# Market Street Gatehouse Project

*2-6 MARKET STREET,  
NEWBURYPORT, MA*

*SITE PLAN REVIEW / SPECIAL PERMIT*

DECEMBER 18<sup>TH</sup>, 2019

# A. Civil Engineering – Revisions

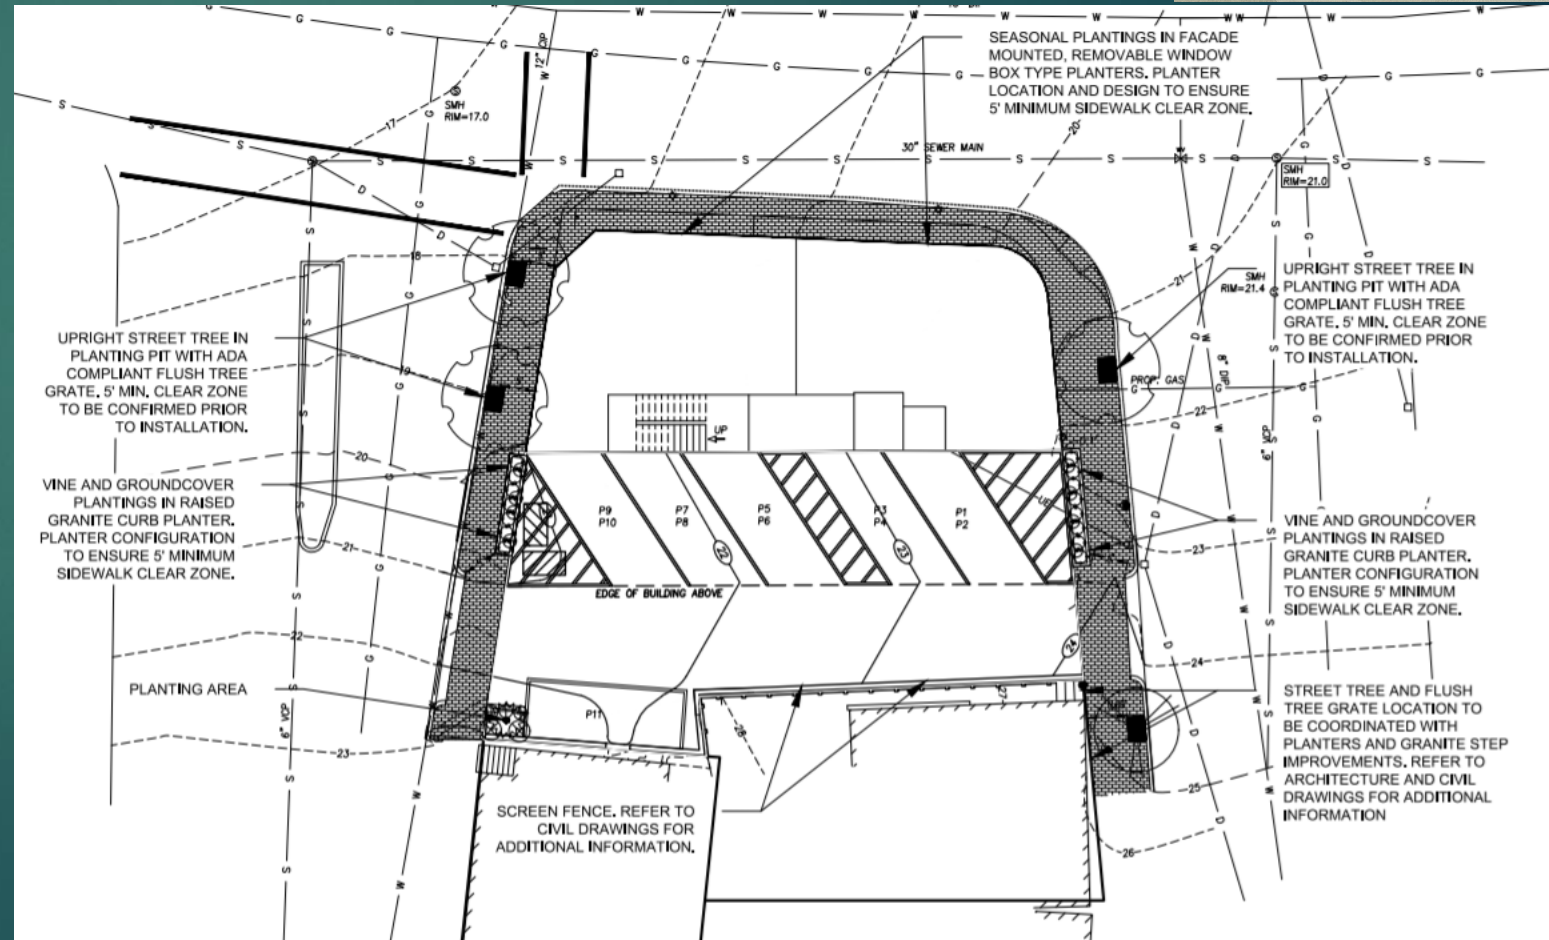
- ▶ Sewer, Water & Electric
- ▶ Drainage & Stormwater Management

- ▶ Demolition & Erosion Control
- ▶ Construction Sequencing
- ▶ Contractor Parking & Hours

- ▶ Sidewalks and Street Trees
- ▶ Steps and Planters
- ▶ Wall and Yard Fencing

# B. Traffic Impacts - Revisions

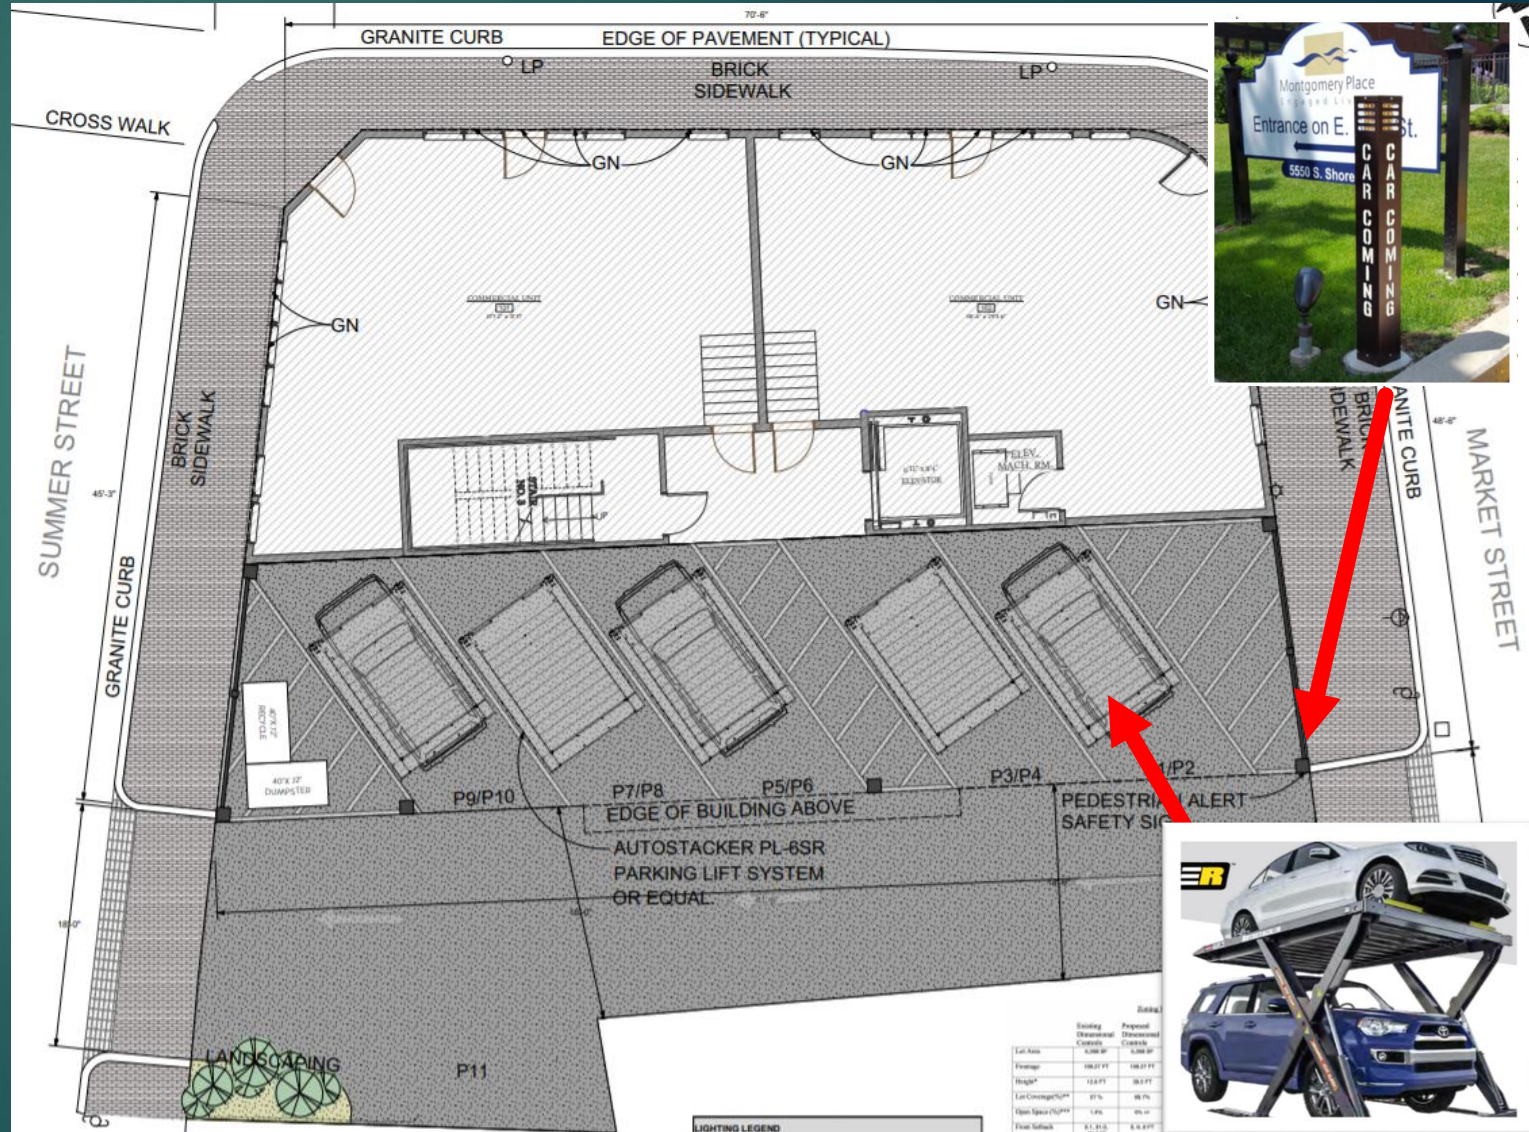
- ▶ Driveway Direction
- ▶ Parking Stall Layout
- ▶ Parking Stacker System
- ▶ Turning Movements

# C. Building Design - Revisions

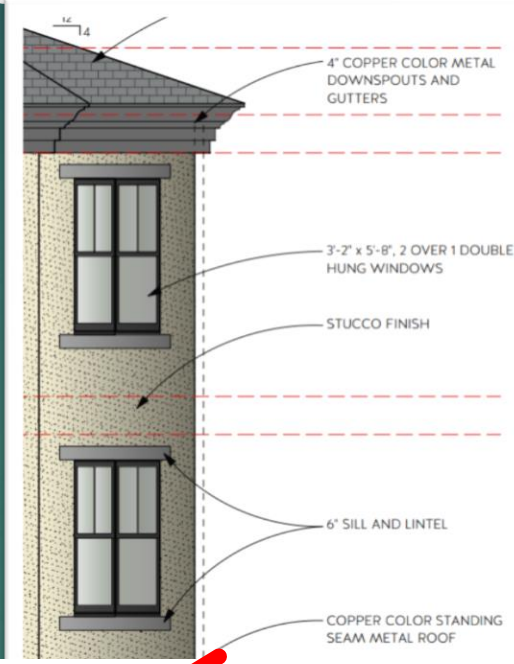
- ▶ Building Materials
- ▶ Parking Screens
- ▶ Lighting & Landscaping
- ▶ Balconies
- ▶ Streetscape Improvements
